**Mill Fork Access #2 Mains
Rilda Canyon Portals 1st
Right Submains
Proposed Bulkheads –
Installation and
Monitoring Plan**

RE: Proposed Bulkhead Installation and Monitoring Plan, Addendum #4, Revised Emergency Response Plan due to Installation of the Mine Separation Seals at 3rd North Deer Creek Mine 42-00121

**Redline Text
For Review Purposes**

Figure 14

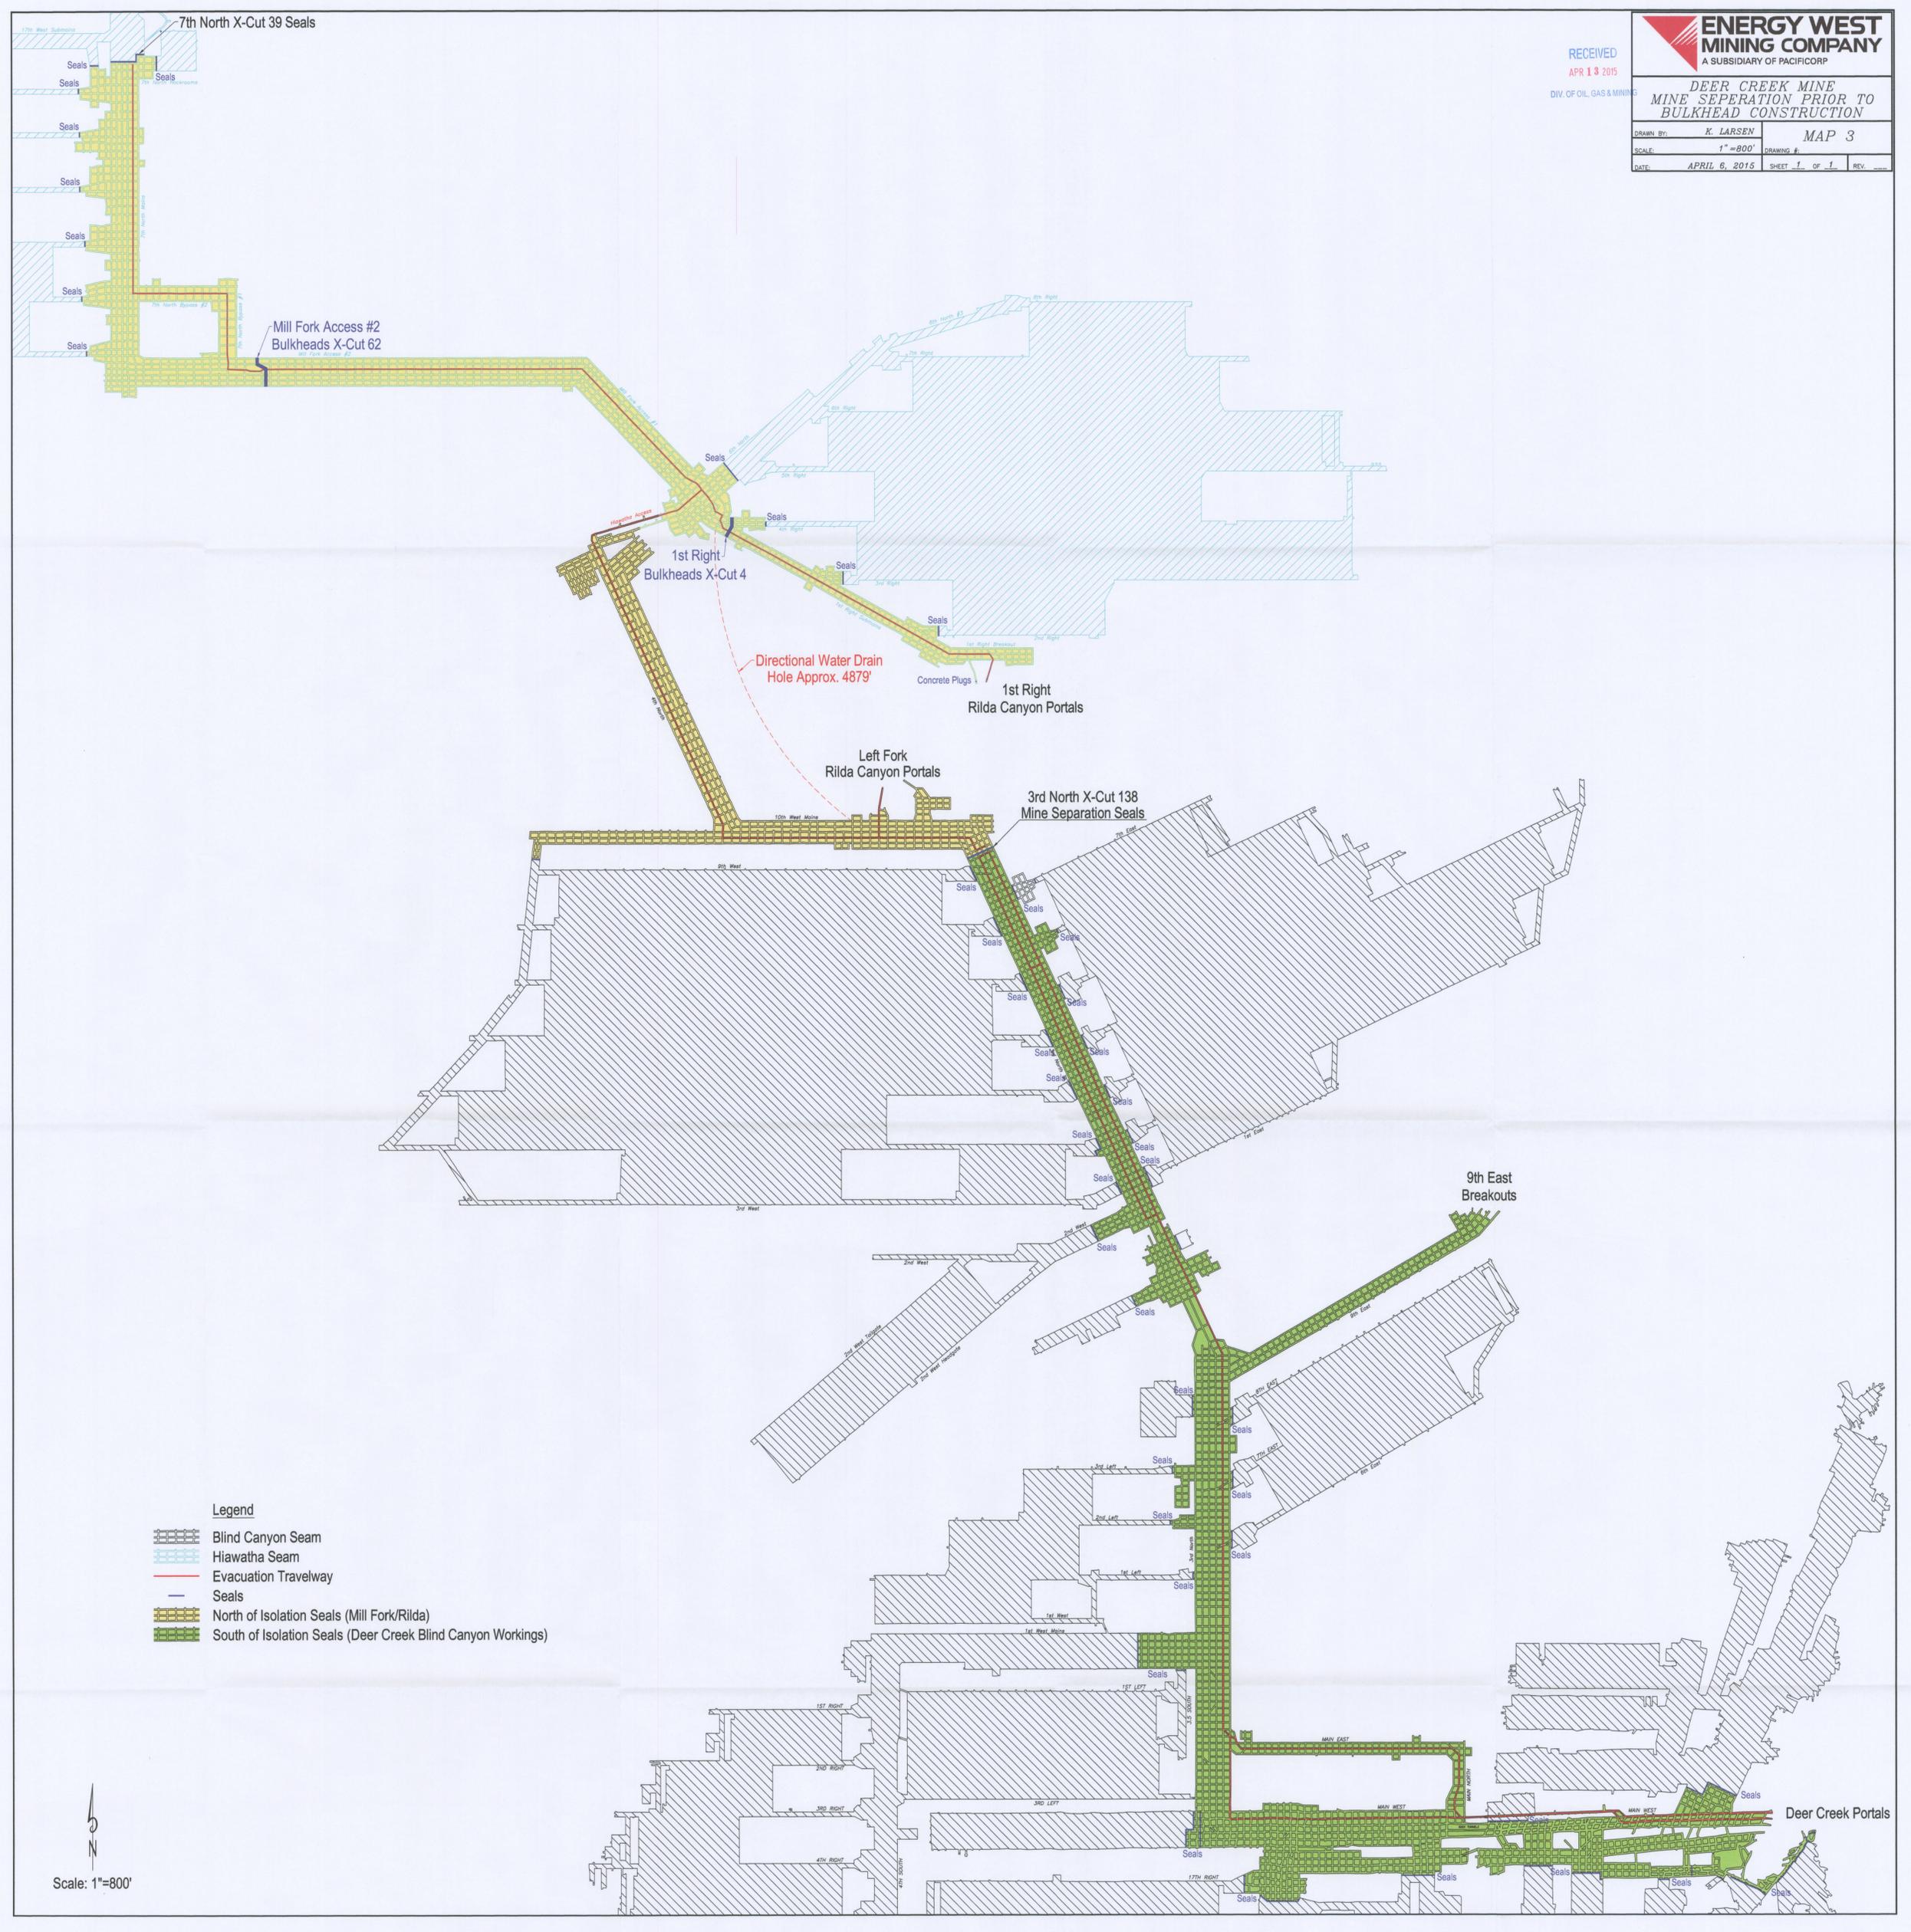
Insert Figure 14

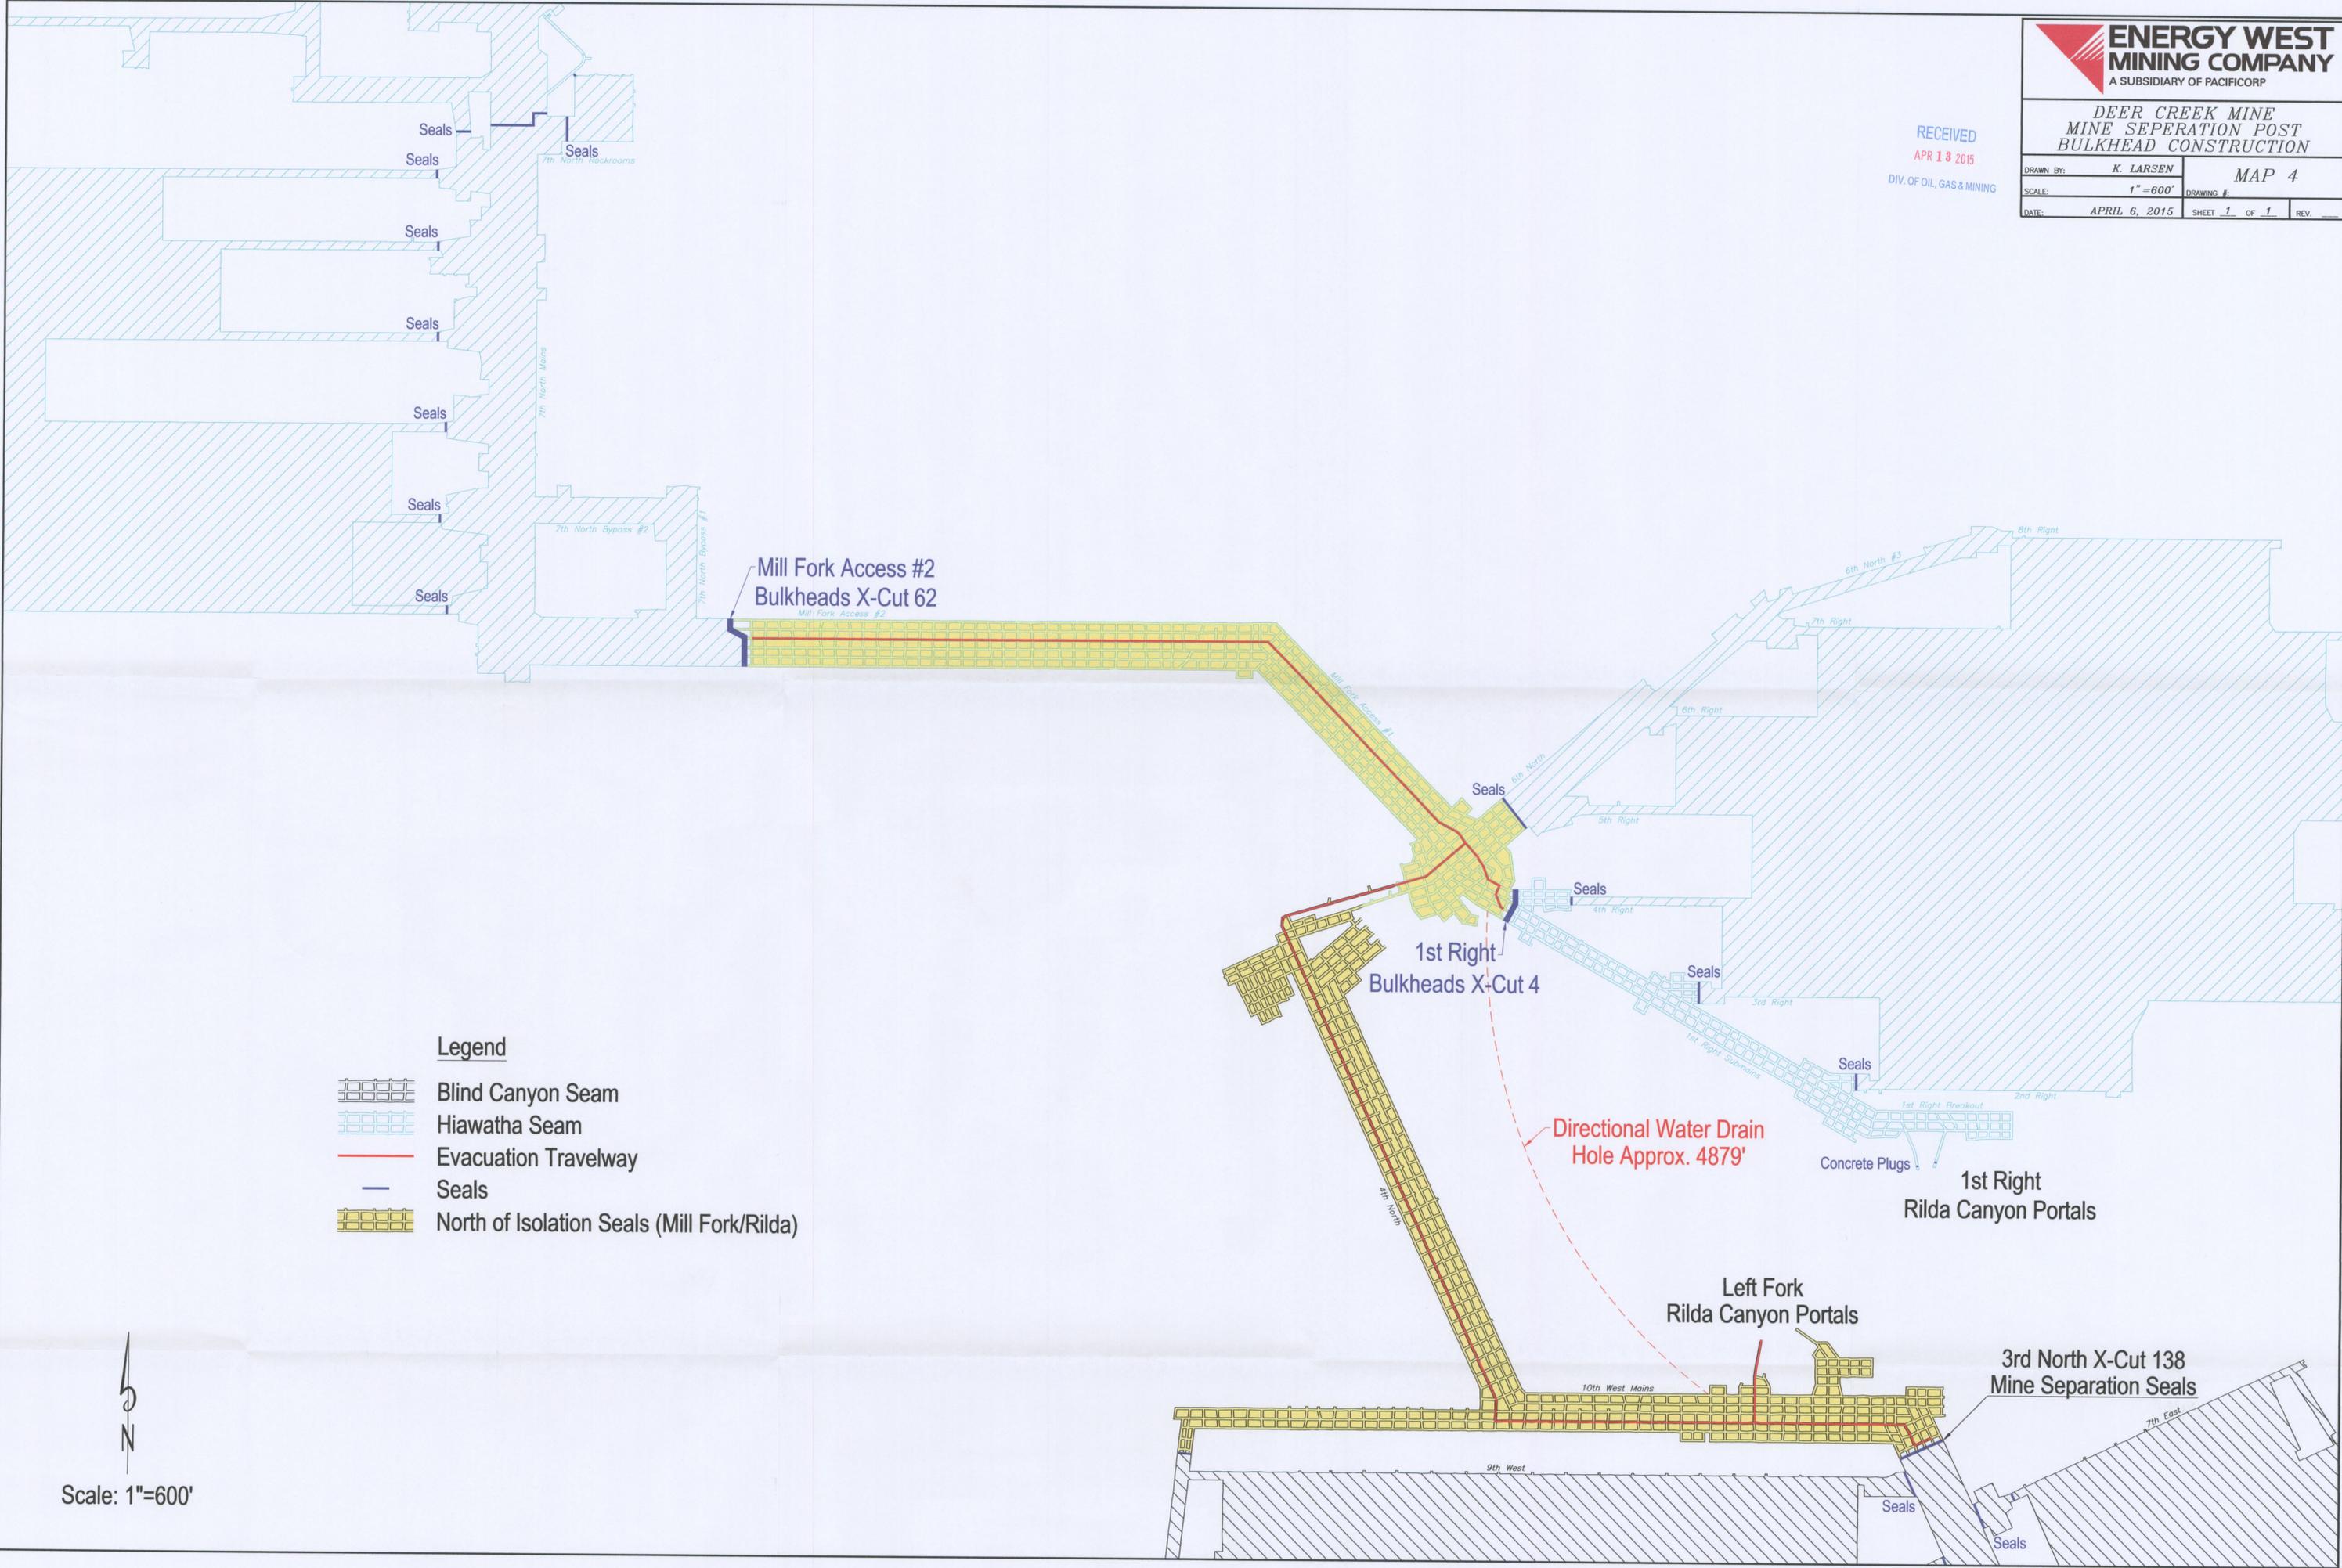
In addition to the installation of the bulkheads, Energy West installed a set of seals in 3rd North B XC-138.5 to further isolate the northern portion of the mine (Figure 9, Maps 3 and 4). Seals at 3rd North B XC-138.5 were approved by MSHA District 9, 4/1/2015. Ventilation changes in the mine were made effective 4/2/2015. Construction and pumping of 120 psi rated seals at the 3rd North B Mains crosscut #138 location commenced on April 6th, Energy West projects final portal sealing at the Deer Creek portals by the end of April 2015. Elevation of 4th North/6th North top-of-slope is approximately 8,010' compared to the 1st Right bulkheads elevation of approximately 7,884' (difference of 126 feet). In the event that water accumulates inby the 1st Right bulkheads (between the 1st Right and Mill Fork Access bulkheads) or if the Mill Fork Access #2 bulkheads fail, the 3rd North B seals are equipped with water drains to allow the water to migrate downdip towards the Deer Creek portals.
